**Government of India**  
**Ministry of Environment, Forest and Climate Change**  
**IA Division**  
**(River Valley and Hydroelectric Projects)**  
 \*\*\*

**Minutes of 7TH MEETING OF EXPERT APPRAISAL COMMITTEE meeting**  
**River Valley and Hydroelectric Projects held from 09/02/2024 to 09/02/2024**

**Date:** 19/02/2024

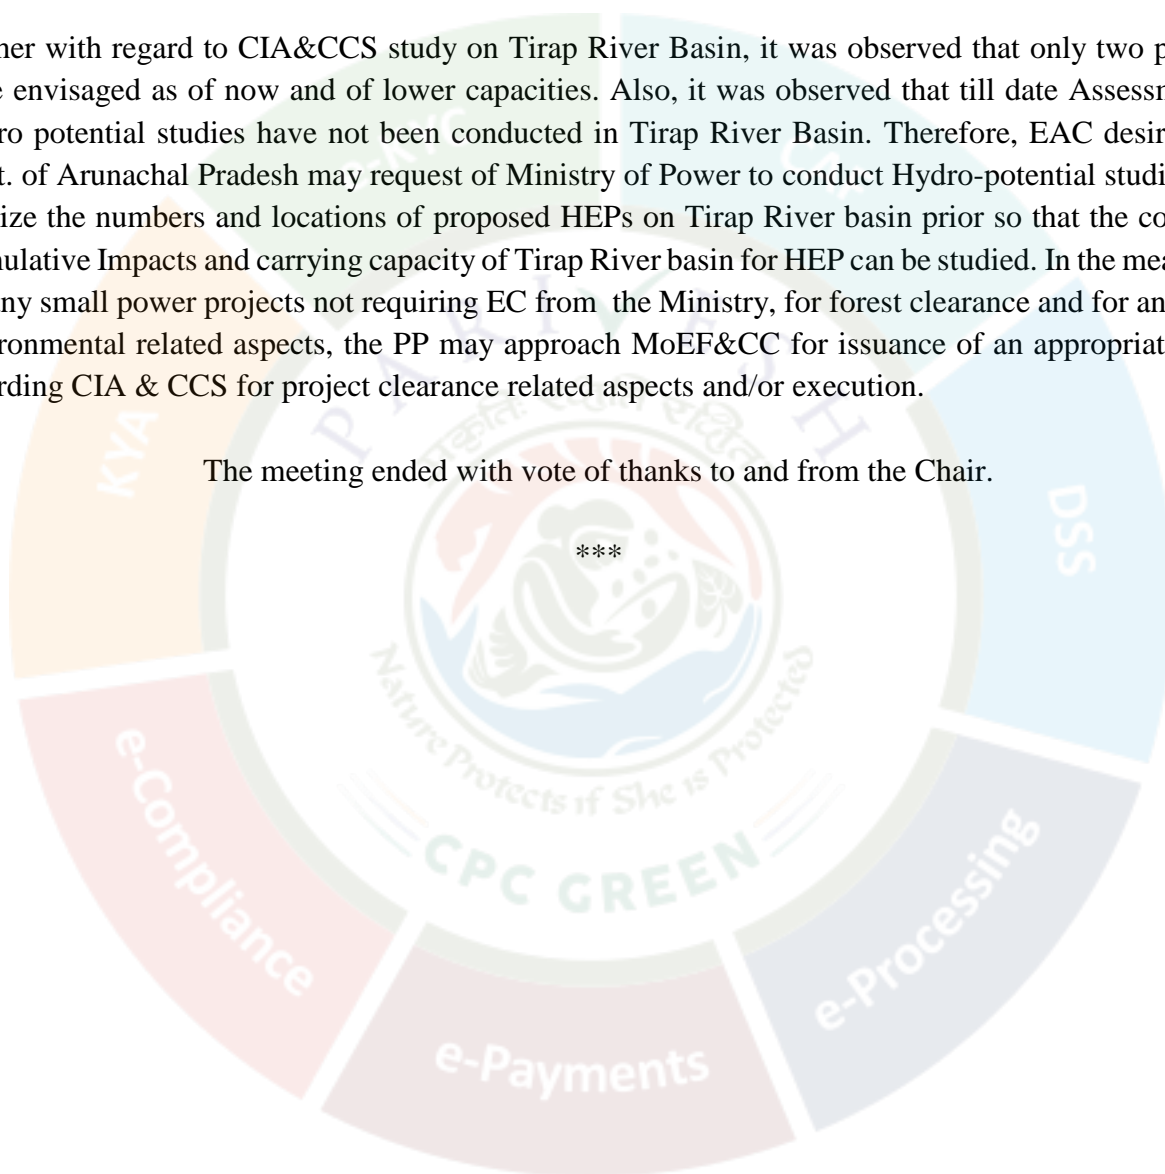
- i. Location map of proposed HEPs on River & River basin networking indicating major tributary of Subansiri, Siang and Brahmaputra river need to relook and the same may be aligned with the google map for clarity. Also, clarify, whether the meeting point of Dikrong river is with Subansiri or Brahmaputra River.

Recently, the Govt. of Arunachal Pradesh submitted a reply of observations by EAC in its earlier meeting as mentioned above. EAC had a detailed deliberation on the subject matter and observed the request to MOEF&CC for conducting Cumulative Impact Assessment and Carrying Capacity Study (CIA & CCS) of Tirap Basin and inclusion of Chinglum Hydroelectric Project & Others in Subansiri Basin.

The Govt. of Arunachal Pradesh had submitted that the Dikrong river is joining with Subansiri River and the confluence point of Dikrong with Subansiri river vide its letter dated 22.06.2023 which is visible from google map/.kml file. Therefore it is clear that the Dikrong River is a tributary of Subansiri river basin in which additional Study was already completed and accepted in the year 2018, Also, it was noted from the Subansiri Additional CIA & CCS study that nine (9) hydro-electric projects envisaged on Dikrong river which have been approved by the Ministry vide letter dated 13<sup>th</sup> April, 2018.

In view of above facts, EAC observed that there is no need for further additional studies of Dikrong river presently. The EAC also opined that Cumulative Impact Assessment (CIA) & Carrying Capacity Study(CCS) conducted for any River basin shall have its relevance for a definite time period. After a long time duration, there may be certain variations in river basin ecology and river morphology i.e. slope of river, drainage pattern of river, catchment area, depth of river, water availability, e-flow, cross section of the river etc. which play a direct role in deciding carrying capacity of the river basin. Therefore, the study may be re-conducted after few years for overall Subansiri River and its tributaries.
